Arlington Conservation Commission

Date: Thursday, January 7, 2021

Notice of Intent: Arlington Reservoir Master Plan Phase 2, 210 Lowell Street Continued Hearing

RE: Revised Plans and information for Arlington Restoration Master Plan Phase II

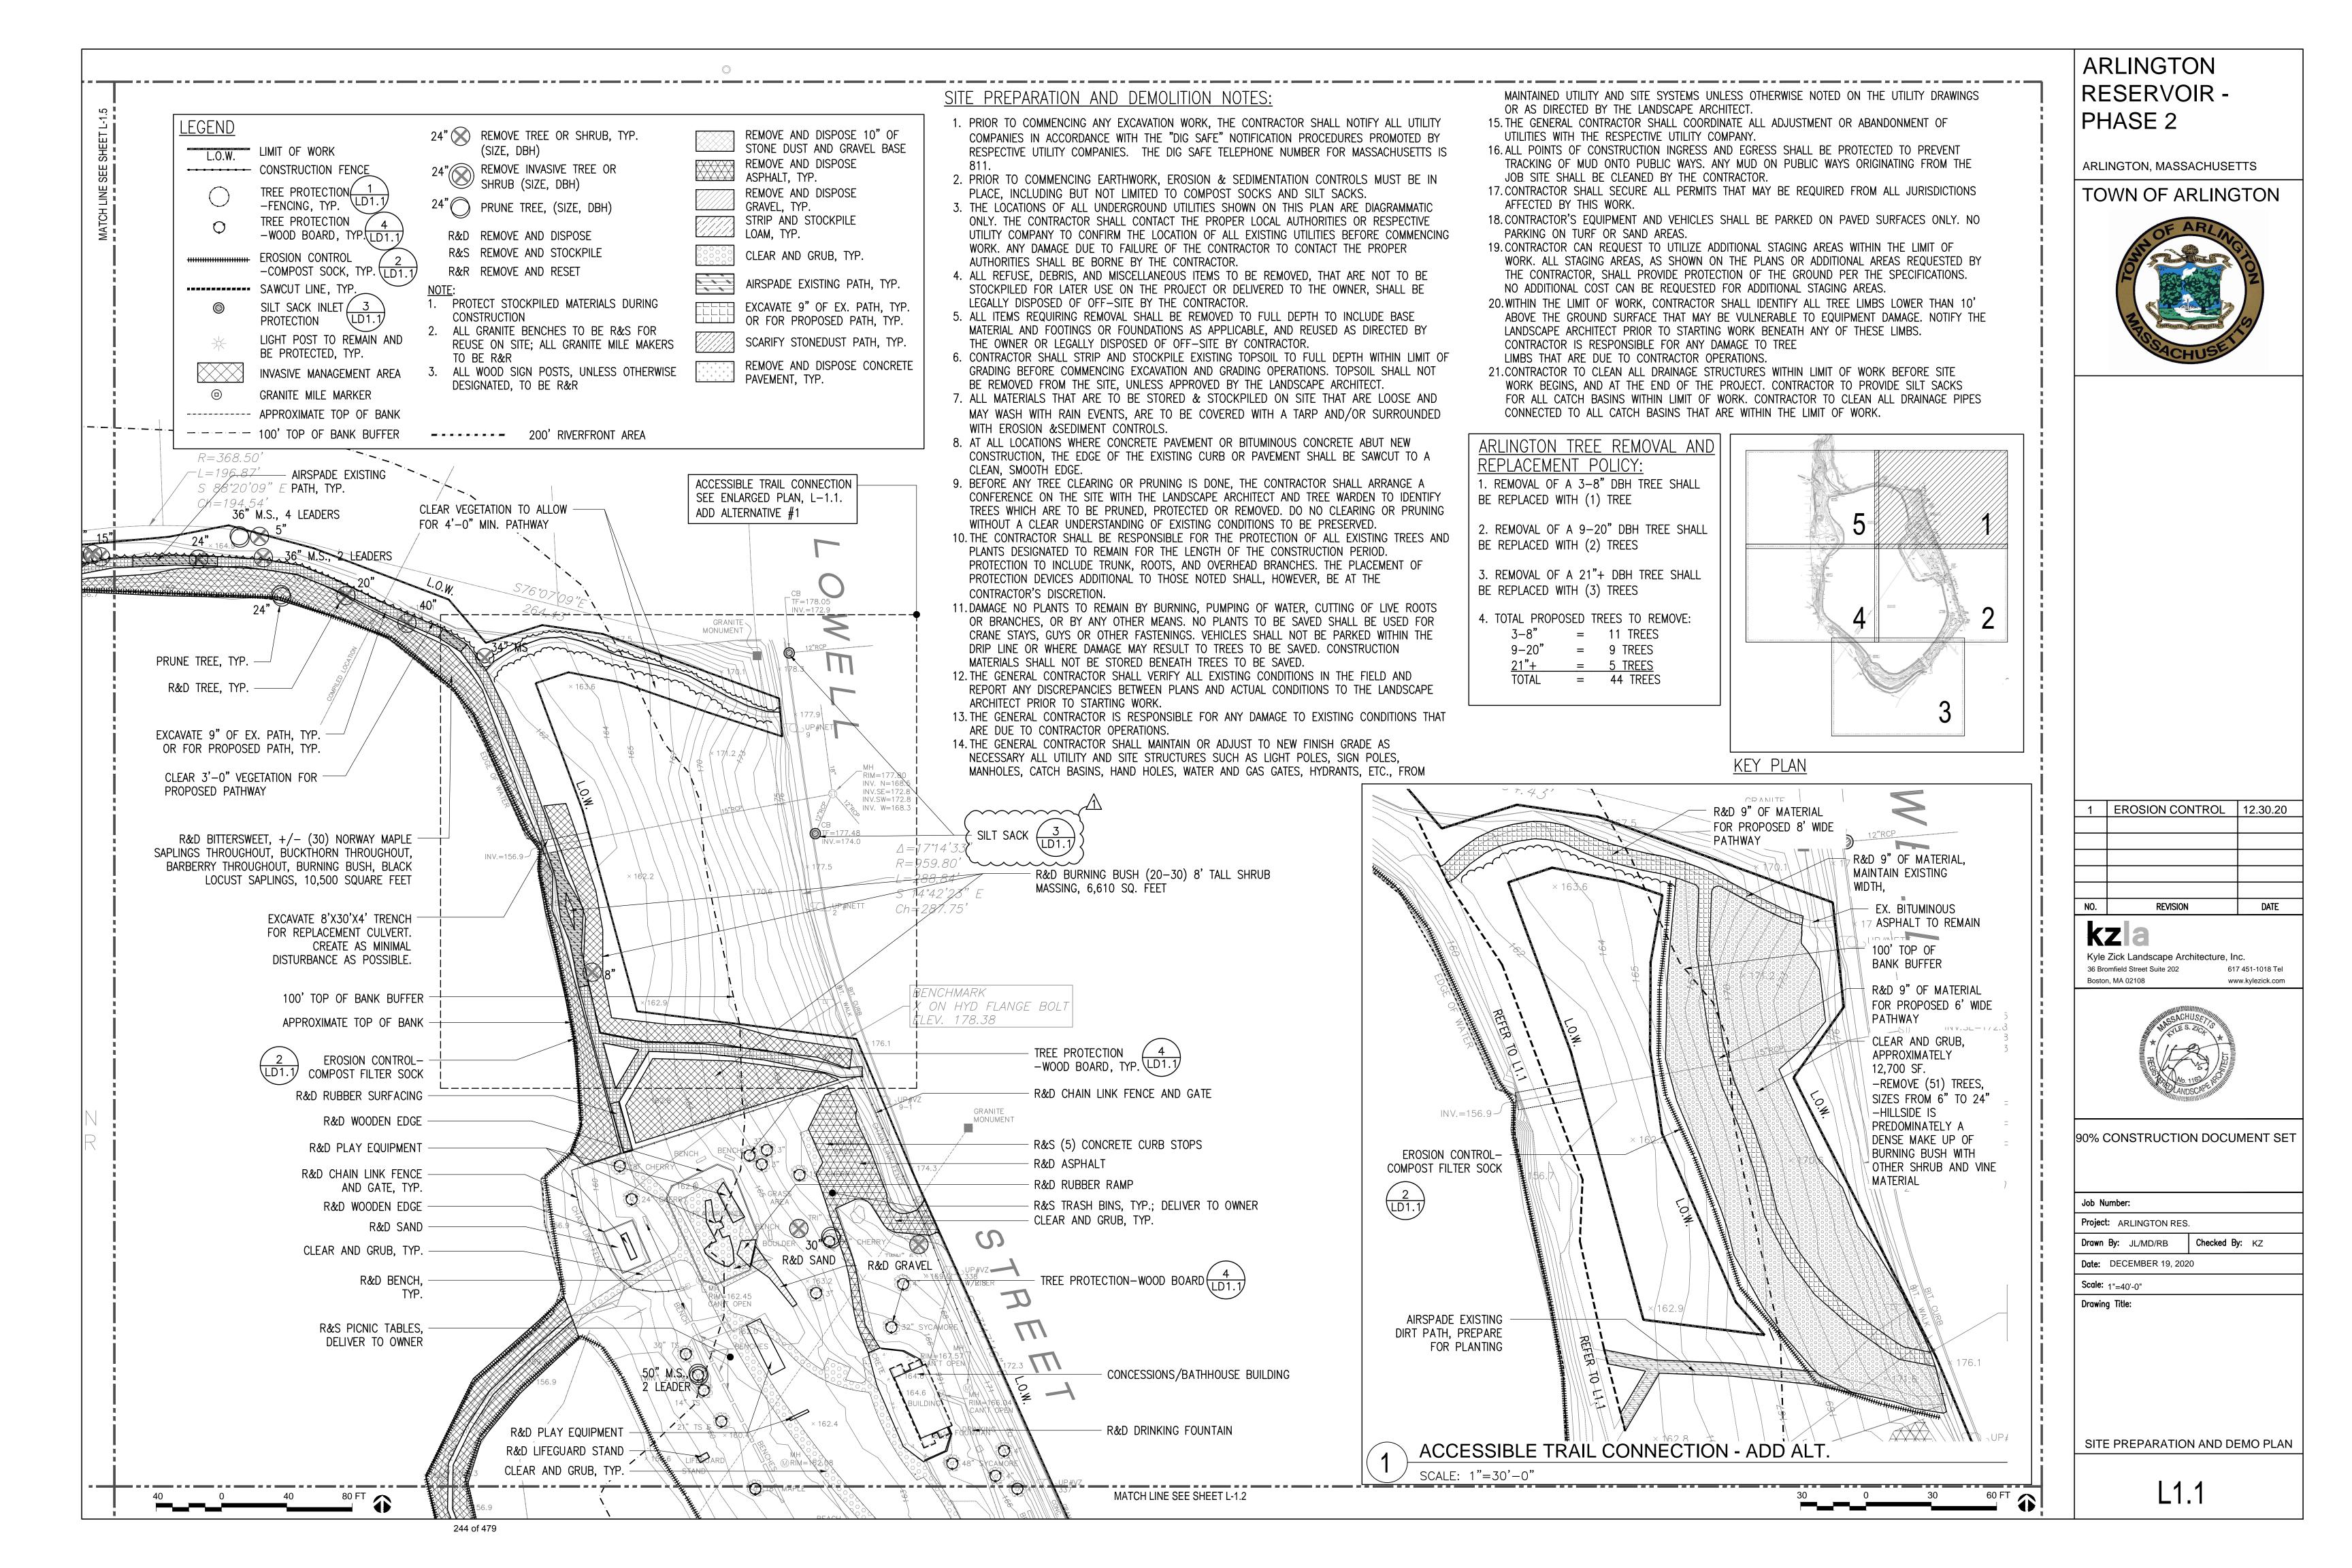
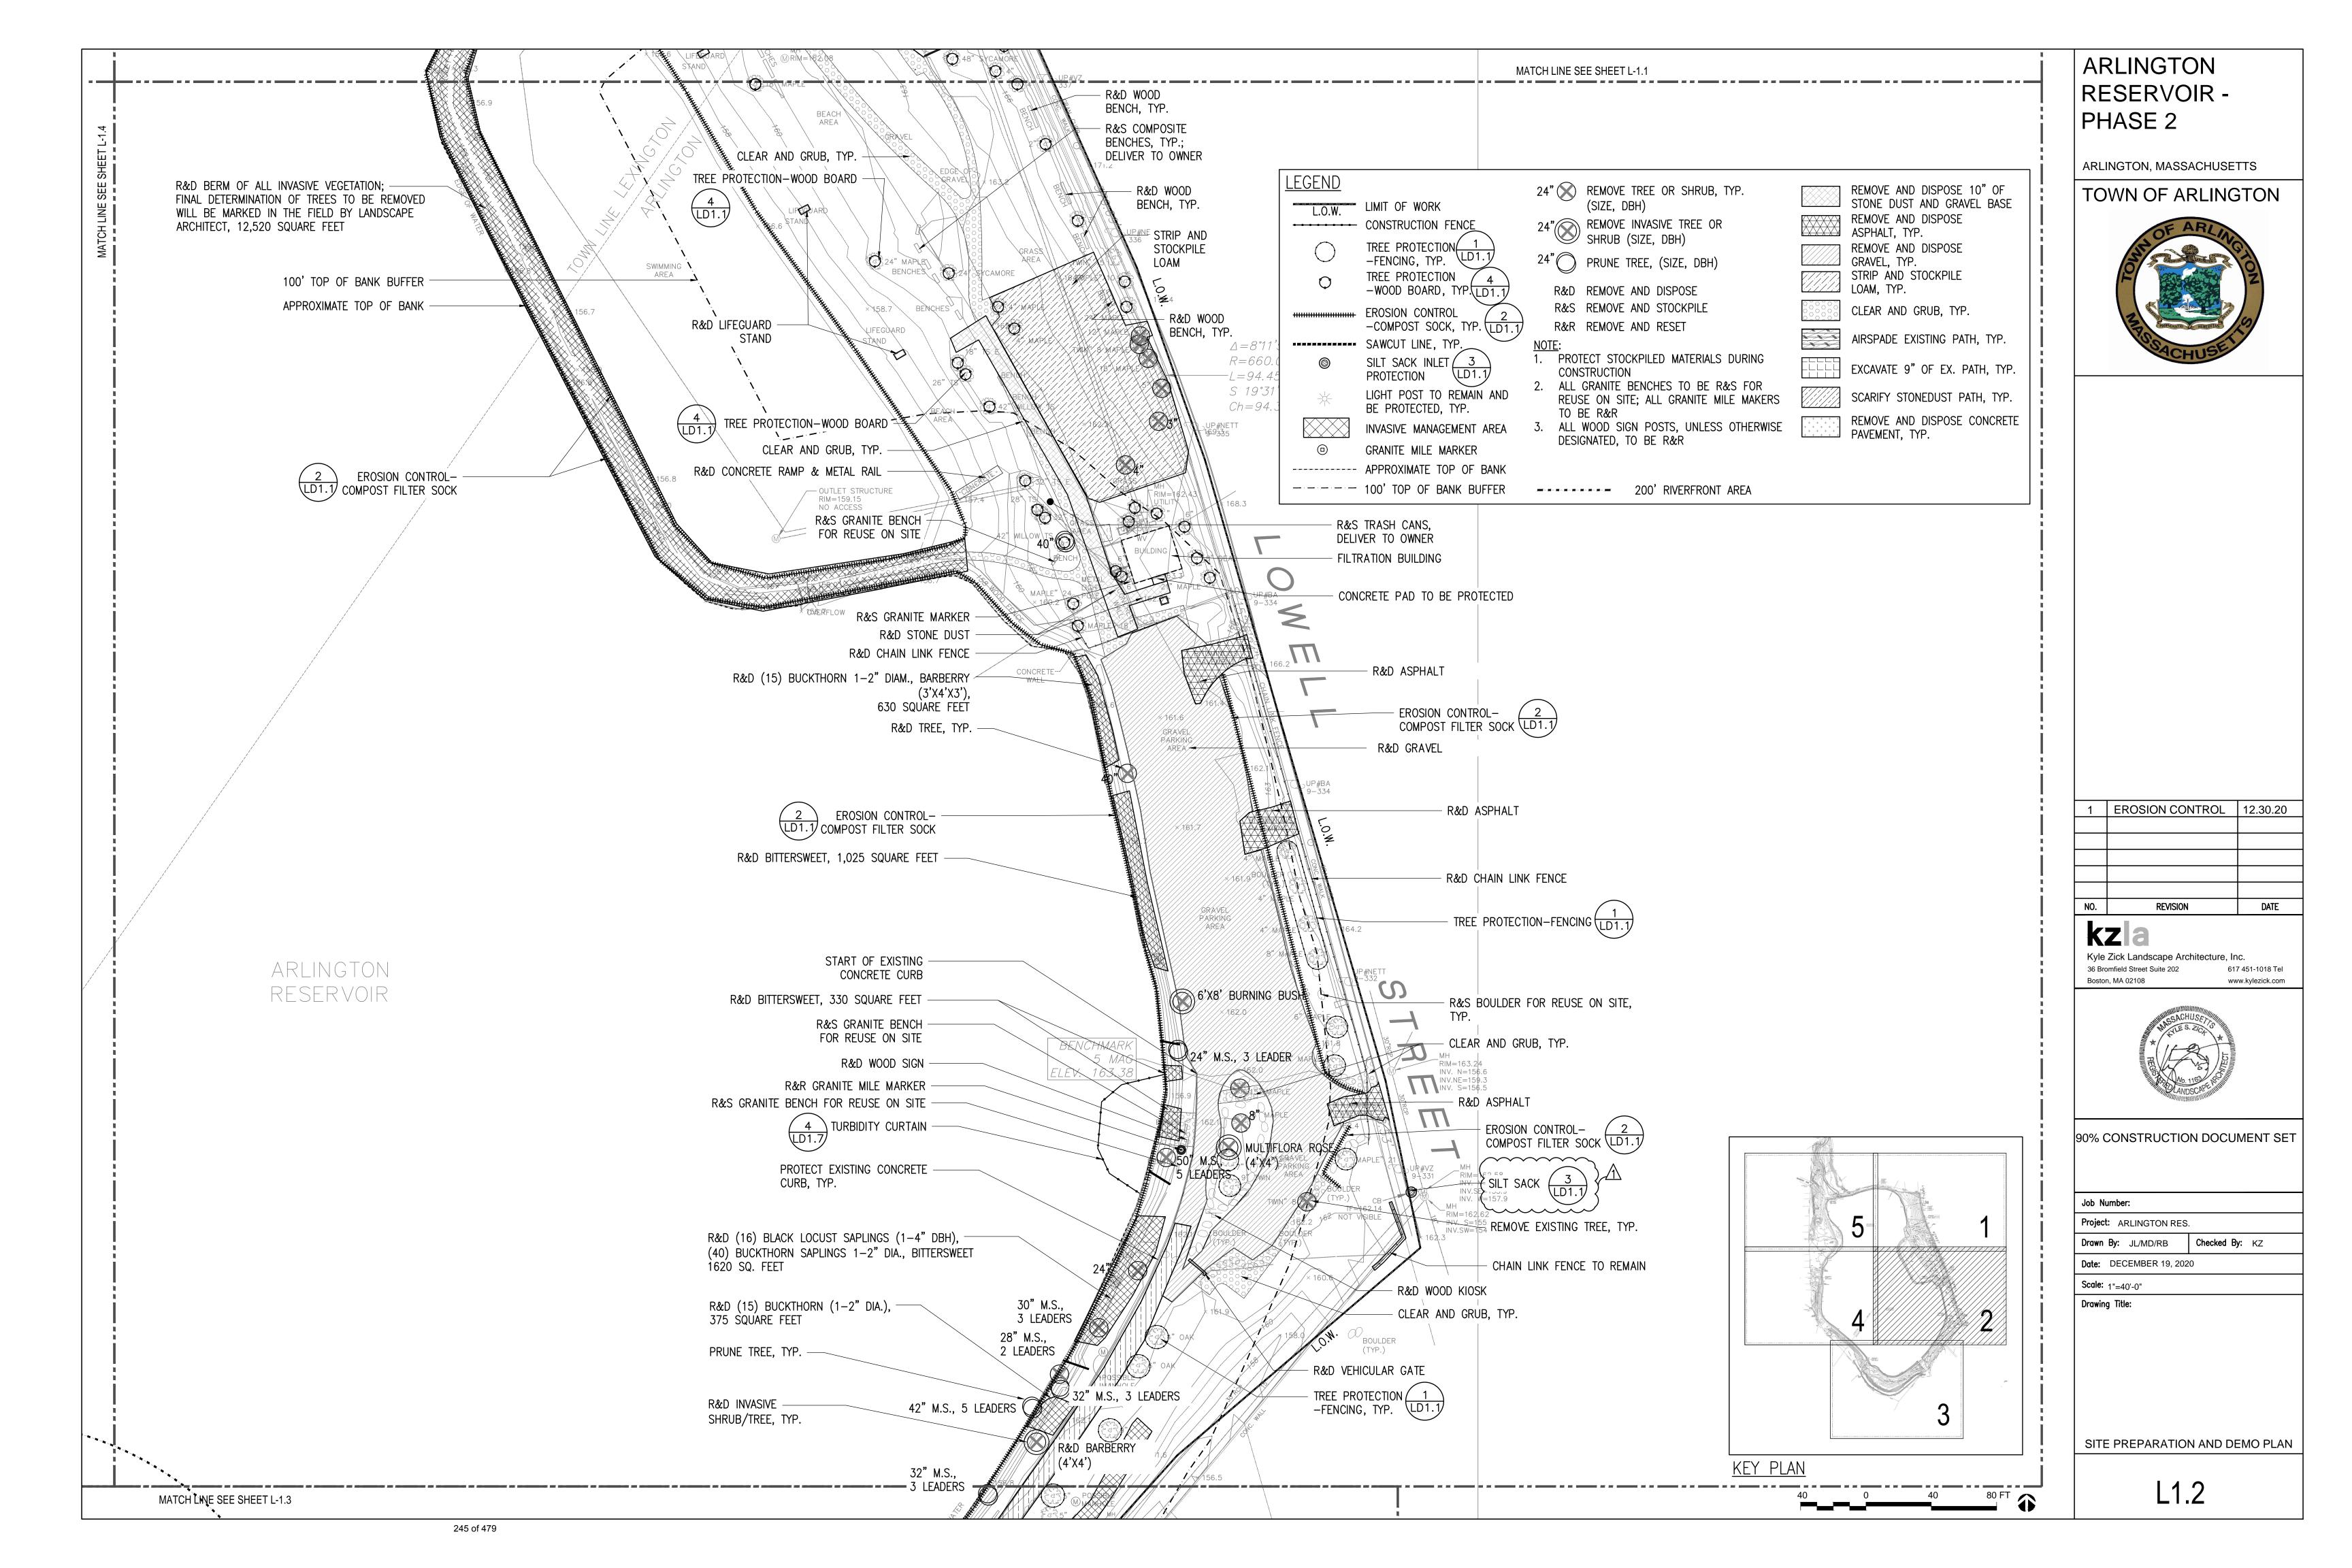
- 1) Information on Lexington's stabilized granite requirements
- 2) Recalculate stormwater calculations using NOAA Atlas 14+
- 3) Review removal/replacement of trees
- 4) Add erosion controls (silt sack) around turf area in parking lot to prevent siltation
- 5) Propose alternatives to glyphosate invasive treatment
- 6) Coordinate with DPW to ensure parking lot is not a snow dump
- 7) Revise parking lot O&M Plan to include regenerative air sweeper
- 8) Revise invasive management to include as much cut-and-dab, not spray, as possible
- 9) Update plan set with changes (erosion controls, plan has erosion control matting near flared end but rip rap might be better)

- 1) Information on Lexington's stabilized granite requirements. A memo from KZLA is attached providing information on this path material and representative examples in the area.

- 2) Recalculate stormwater calculations using NOAA Atlas 14+. A revised stormwater report dated December 2020 is attached. This report has been prepared by Woodard & Curran Engineers and is stamped by Denise Cameron, PE.

- 3) Review removal/replacement of trees. The KZLA memo addresses this item and the planting plans (Sheets L4.1 and L4.5 have been revised. These plan revisions are attached.

- <u>4) Add erosion controls (silt sack) around turf area in parking lot to prevent siltation.</u> The civil site plans have been revised to show compost filter erosion controls socks, and stone rip rap at the outfall pipes. These are shown Plan C1.0 and C2.0. Both revised plans are attached.
